2: Issue Addendum #02

Boat Grid Remediation – Fisheries and Oceans Canada

Porpoise Bay Government Wharf - Sechelt, BC

ANSWERS TO BIDDER QUESTIONS

AERIAL OVERLAY OF SCH PORPOISE BAY

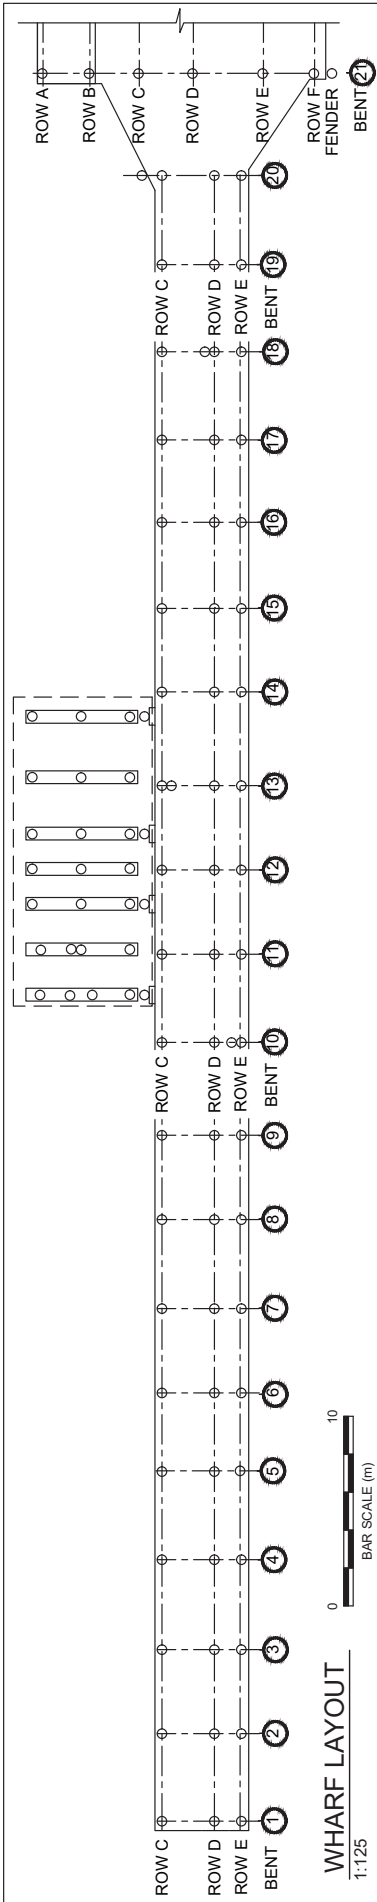
QUESTION 22: As per the specifications: "The Contractor shall not enter on nor occupy with men, tools, equipment or material, any ground outside the property of the Harbour Authority without the written consent of the party owning such ground".

Can a map be supplied indicating the boundaries of the Harbour Authorities' property, exclusion zones within the harbour, etcetera.

ANSWER 22: Yes, please see the Aerial Overlay attached

Client:  Fisheries and Oceans Small Craft Harbours Branch	Drawing Title: WHARF AND FLOAT REPAIRS PORPOISE BAY SMALL CRAFT HARBOUR BOAT GRID LAYOUT		Draftsman: -	Scale: NTS
			Date: JULY 2020	DWG: PB-HR-008

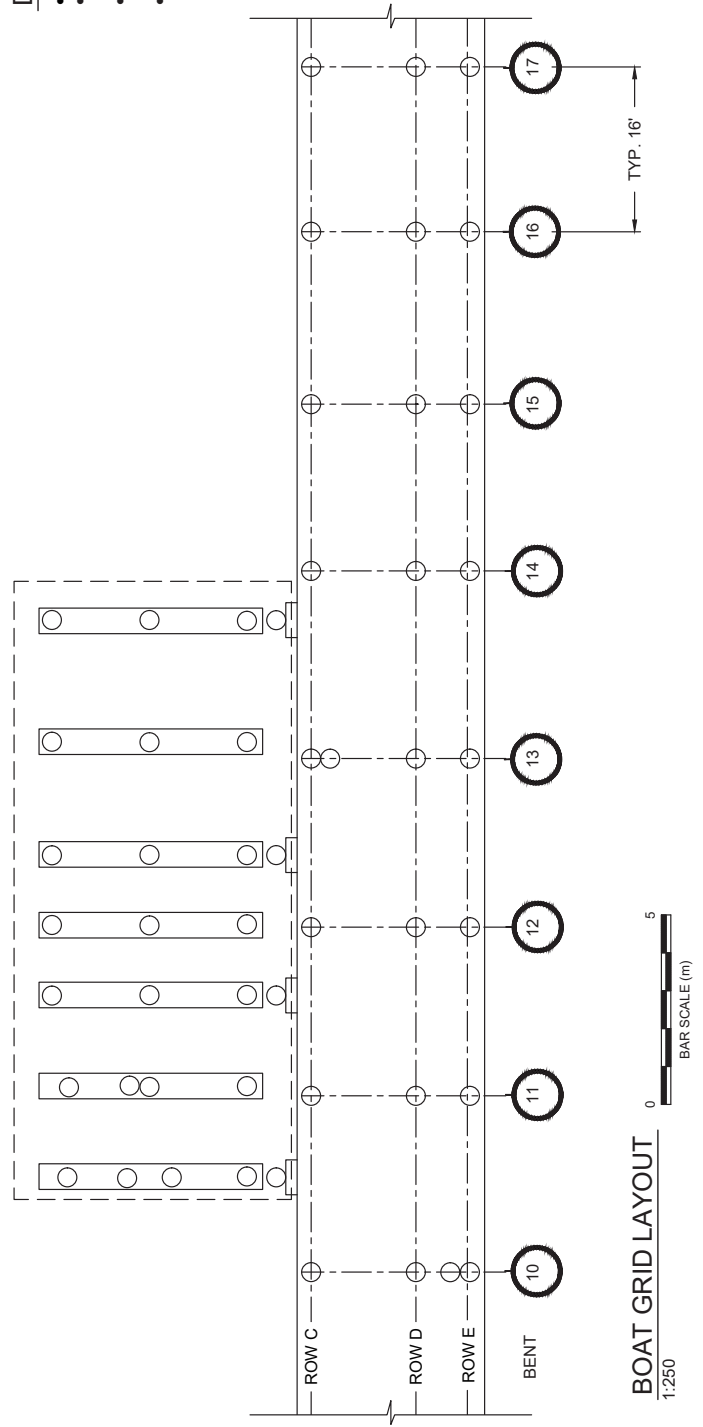
QUESTION 5: Can you provide information on the wharf weight capacity and dimensions?

ANSWER 5: Please see the dimensions on the attached site plan. The load limit as posted on site is the following:

Drawing Title: Cross Braces and Walers
PORPOISE BAY SMALL CRAFT HARBOUR

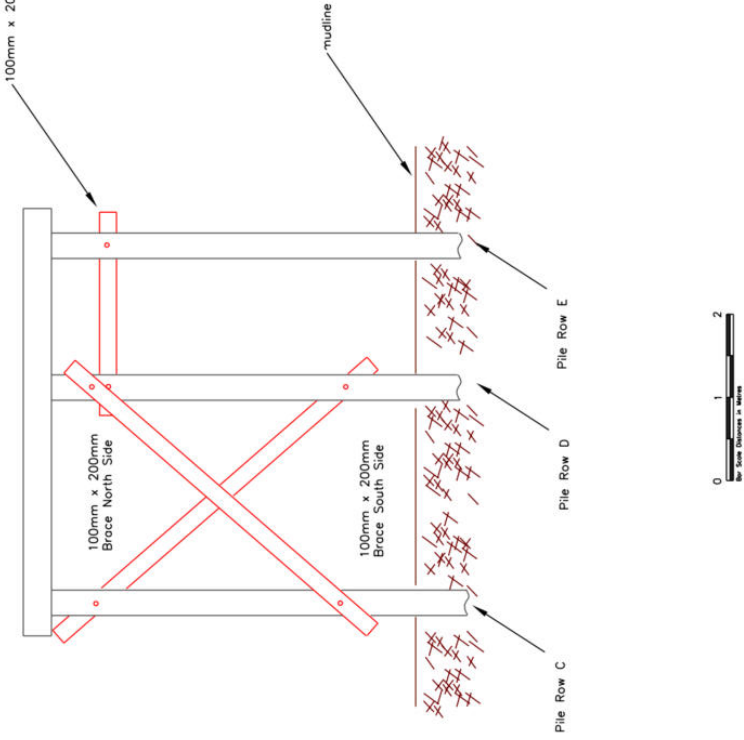
QUESTION 11: Section 35 20 23 Excavation/Dredging, Part 3.1.5 : *Contractor to determine suitable side slopes to avoid damaging or undermining adjacent eelgrass bed and wharf support piles. If the eelgrass bed is disturbed or impacted by the excavation works, side slopes or sediment control devices, the Contractor will be responsible for replanting the eelgrass at a ratio of 2:1. If support piles are damaged, the Contractor will be responsible for replacement or repair costs.*

Can a bracing plan for the approach be made available?

ANSWER 11: Please refer to the Porpoise Bay - Braces and Walers table attached as well as the drawing attached.
